UNITED STATES PATENT AND TRADEMARK OFFICE

| APPLICATION NO. | FILING DATE | FIRST NAMED INVENTOR | ATTORNEY DOCKET NO. | CONFIRMATION NO. |
|---|-------------|----------------------|---------------------|------------------|
| 10/574,220 | 07/07/2006 | Tatsuo Tsutsui | P29489 | 2156 |

| Office Action Summary | Application No. | Applicant(s) | |

DETAILED ACTION

Fig A

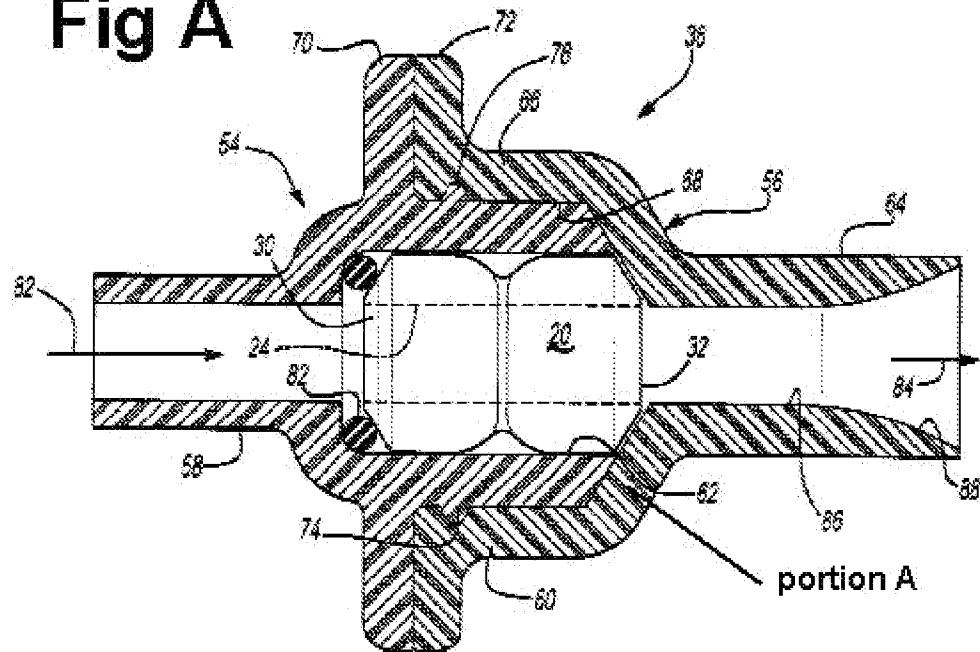
6. Re claim 1, Cocozza discloses a device ("insufflator" best seen in Fig 9) to deliver a powdery medicine (Col 4, Lines 6-7) for nasal cavity to spray a powdery medicine filled in a capsule 13 (Fig 9) by loading the capsule between a connection port 37 (Fig 10) on a side of a nozzle 32 (Fig 10) to spray the powdery medicine into the nasal cavity and a connection port 35 (Fig 10) on a side of a pump 33 (Fig 9) that supplies spray air to the nozzle (Col 4, Lines 23-25), the capsule being formed with a hole on each end (formed after cutting; Col 1, Lines 61-63) in communication with a respective one of the connection ports (Col 1, Lines 61-63) and supplying spray air from the pump through the inside of the capsule to the nozzle, a capsule holder 12 (Fig 15) that holds the capsule filled with the powdery medicine and is slidably movable in the longitudinal direction thereof (Col 3, Lines 18-20 and Lines 65-66), the capsule holder configured to position the capsule in a loading position between the connection port on the side of the nozzle and the connection port on the side of the pump (when capsule

13 is in line with cavities 35 and 37; Col 3, Lines 67-68), the capsule holder being movable forward and backward relative to the loading position of the capsule (Col 3, Lines 65-68); a cutter 20, 20' (Fig 13 and 14) that partially cuts off both ends of the capsule that moves forward to the loading position while being held by the capsule holder to make the holes on opposite ends of the capsule (Col 3, Lines 63-64), the cutter including a pair of blades 20, 20' (Fig 13 and 14) secured in parallel with each other (Col 3, Lines 30-44), each blade having a blade tip directed in a direction opposing the advancing direction of the capsule holder (Col 3, Lines 30-44; Fig 13 and 14); and a positioning guide 11 (Fig 11) located forwardly of the cutter to guide the ends of the capsule that moves forward to the loading position while being held by the capsule holder and causing the capsule to slide as far as a predetermined position (capsule holder 12 abuts protrusion 19 of the positioning guard 11; Col 3, Lines 24-27). Coccozza does not disclose that the peripheral portions of both of the connection ports are formed as seal projections that project from surfaces of the blades toward the loading space; nor does Coccozza disclose that the distance between the seal projections is shorter than the length of the capsule after cutting off both ends by the cutter, so that both ends of the capsule loaded between them is pressed by both seal projections. Sullivan et al., however, teach a substantially similar device having connection ports 58, 64 (Fig 4) that have peripheral portions (formed by O-ring 82 (Fig 4) and portion A (best seen in Fig A below)) formed as seal projection that project from the ports toward loading space 62 (Fig 4) so that the distance between the seal projections is shorter than the length of a capsule 20 (Fig 4) after which the capsule has

been opened (Para 29) (as seen in Fig 4) so that both the ends of the capsule loaded between them are pressed by both seal projections (Para 35) for the purpose of assuring a sealed relation between the capsule and the device (Para 35). Therefore, it would have been obvious to one of ordinary skill in the art at the time the invention was made to modify Cocozza to include seal projections, as taught by Sullivan et al., projecting from the surface of the blades for the purpose of assuring a sealed relation between the capsule and the device (Para 35).

Fig B

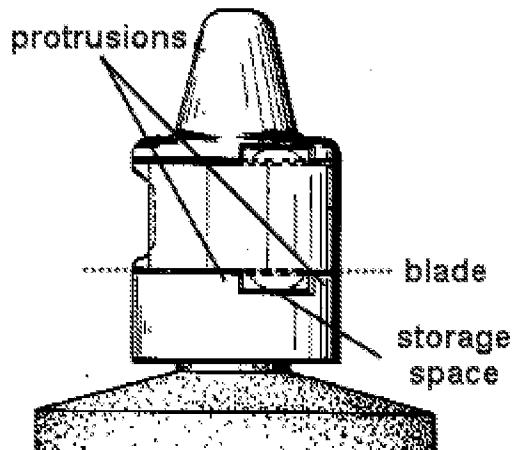
7. Re claim 2, Cocozza discloses that the positioning guide includes a pair of protrusions (best seen in Fig B below) opposed to each other and a storage space 30 (Fig 4) is formed between blades and the protrusions placed on a side thereof for

discharging cut ends of the capsule cut off by the blades (Col 3, Lines 62-64).
